Global Nuclear Fuel

Pre-Submittal Meeting for the New Powder Container Safety Analysis Report Revision

June 5, 2019

Chapter 6 – RAI 6.3

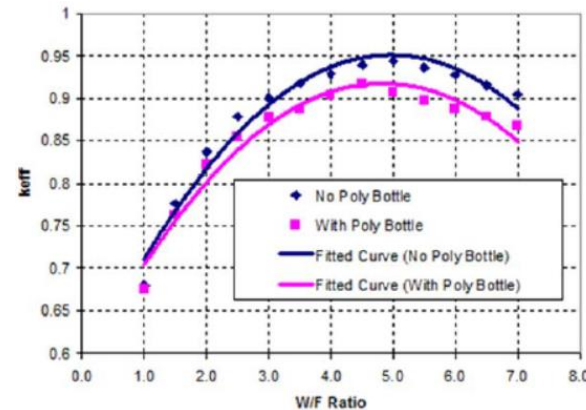
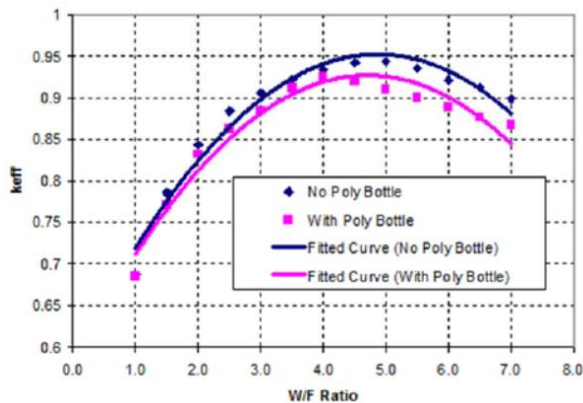
- RAI 6.3: *“Either provide a minimum weight limit for packaging materials with a hydrogen atom density greater than that of water or demonstrate that the package and the increased BWR/PWR pellet payloads remain subcritical in the absence of these packaging materials. [...]”*
- Approach: Remove weight limit for packaging materials for a hydrogen density less than water.
 - As shown in RAI 6.2, modeling the HDPE packaging materials is less reactive than including them. Additional sensitivity studies will be provided in NEDO-33881 Section 6.12.
 - NEDE-33881P Table 1.1 Note 4 was revised to remove the HDPE limit to state: *“Mass of plastic bags or poly bottles used for inner packaging is unrestricted provided the mean hydrogen atom density of the material contents to be shipped inside the inner volume of each ICCA is not greater than water.”*

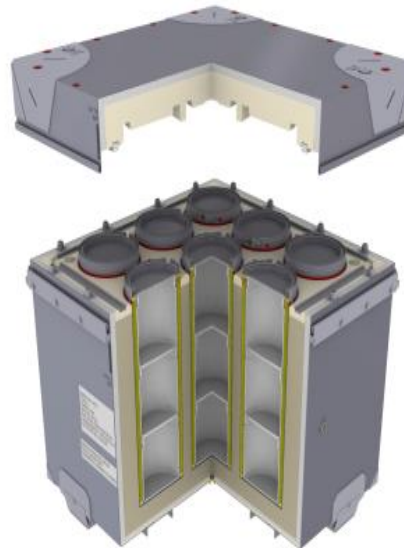
- RAI 6.4: *“Demonstrate that the package with the proposed new contents remains subcritical when uranium-bearing contents are moderated by carbon to any degree. [...]”*
- Approach: Remove carbon as a moderator from Page 6-3.

“Uranium-bearing contents may be moderated by water ~~or carbon~~ to any degree and may be mixed with other non-fissile materials with the exception of deuterium, tritium and beryllium.”

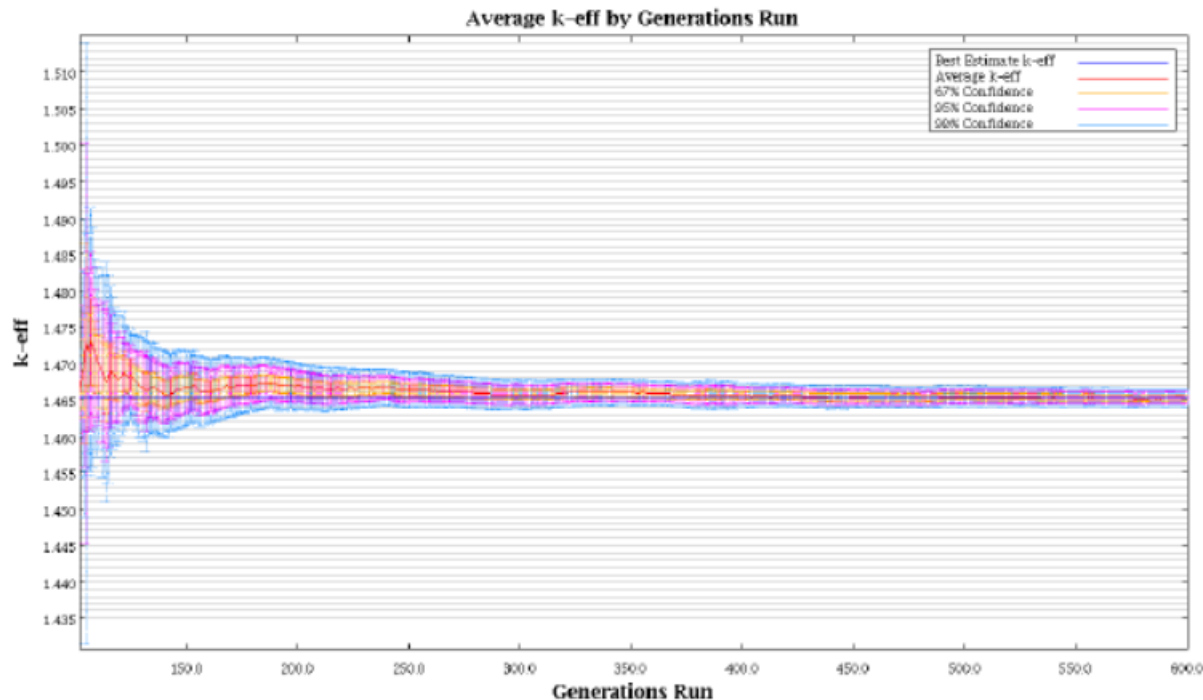
- RAI 6.6: “*Demonstrate that the Monte Carlo calculations converge. [...]*”
- Approach: Update Figure 6.10e to show GEMER code convergence.
 - The current set of GEMER convergence figures are a composite illustration of the batches run and the batches skipped. Where the left-half of the figure is for the batches executed and the right-half is for the batches skipped.
